Rymill Park Apartments Pty Ltd and Rymill Park Apartments Unit Trust

Demolition of existing office building and construction of 16 level mixed use building

2-6 Hutt Street, Adelaide 5000

DA Number 020/A081/17

Figure 1 - Edge of shadow at 12:51 on 21 June 2018

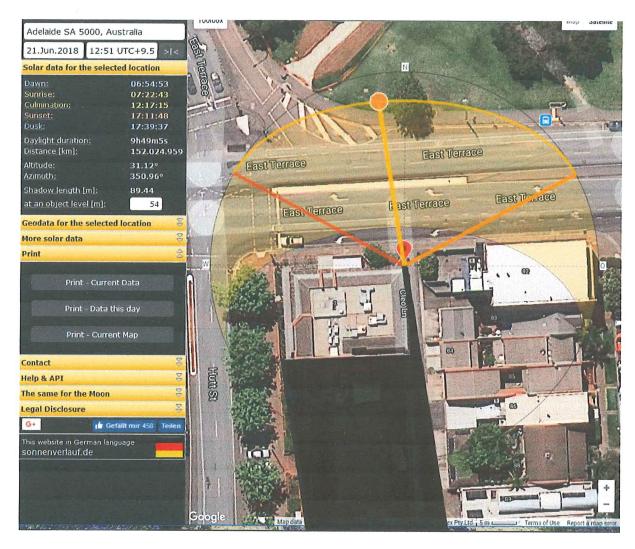
The DP provides no information on solar shading so this effect has had to be calculated independently. An edifice 54.9m high and 27m wide will seriously reduce the amount of sunlight available at 85 East Terrace at any time of year. Figures 1 and 2 below show that the PD will, on the 21st of June 2018, cast a shadow over 85 East Terrace commencing at 12:51pm and remaining until dusk. The statement in Section 7.7.1 Overshadowing that a building of 54m would have neglible extra impact over a building of 22m is manifest nonsense. The shadow cast will extend more than twice as far down East Terrace. It will affect properties much further down East Terrace.

Figure 1: Building Height Concept Plan Figure CC/2

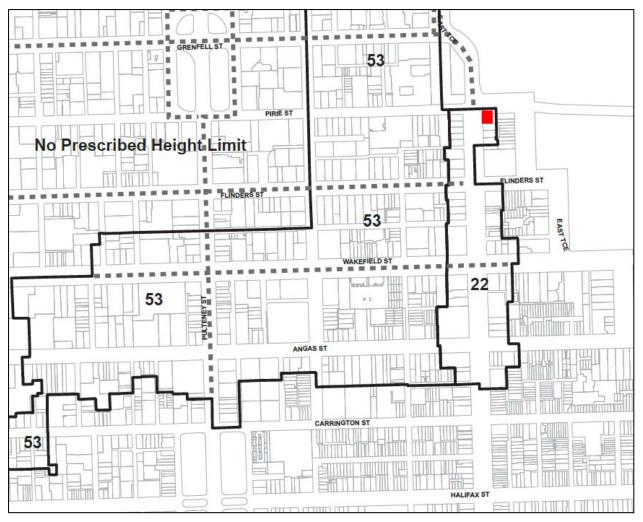
It is acknowledged that the Development Plan seeks a high level of activity and density of development within the Capital City Zone, which the proposal seeks to achieve through the 18 levels of residential, commercial and car parking proposed. The Development Plan however is clear in seeking a reduction in height and intensity at the interface with the City Living Zone. The Building Height Concept Plan Figure CC/2 within the Capital City Zone shown in Figure 1 below articulates the desired reduction in intensity from the Central Business Policy Area (no height limit) down to 53 metres, then 22 metres for the subject land and 14 metres for the properties along the adjacent portion of East Terrace. The proposal has a height of 53 metres.

East Terrace Morning Traffic Photo-1

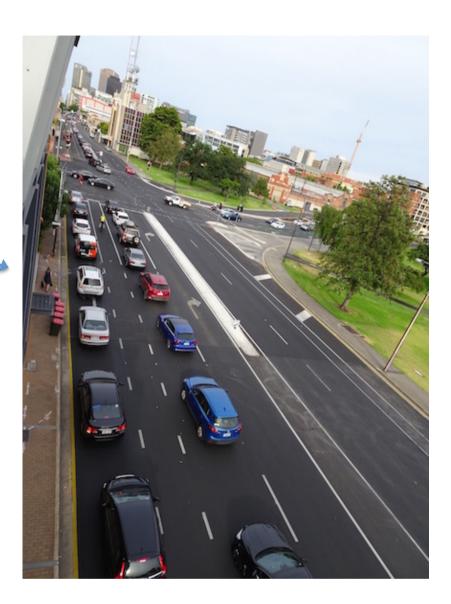
The specific aspects of the applicat	on to which I make comment on are:	
	ement of the Cleo Lane. As I explained in the	
ooth drivers as well as pedestrease the difficulties of the income	consuming even with current small number of the Lane exit. The point of the Lane exit. The point drivers to the Lane, but will not work for the already very short distance between the consumer of the consum	oroposed two-lane approach may For the outgoing cars because the
1	tical (as explained in the photo 3). With this	
	y to a driver at the Lane exit is unrealistic. C	
1 0	afety issues. As changing the plan is almost:	1
	t any compromise from the beginning. Con	
	ssment Panel conduct a public hearing for this Develop	
do n	to be heard in support of my submission ot wish to be heard in support of my submission use tick one)	→ The only viable solution for this building is to make a driveway facing Hutt St. The short distance problem of this drive way to the Hutt St.

East bound morning traffic in front of 2 East Terrace.
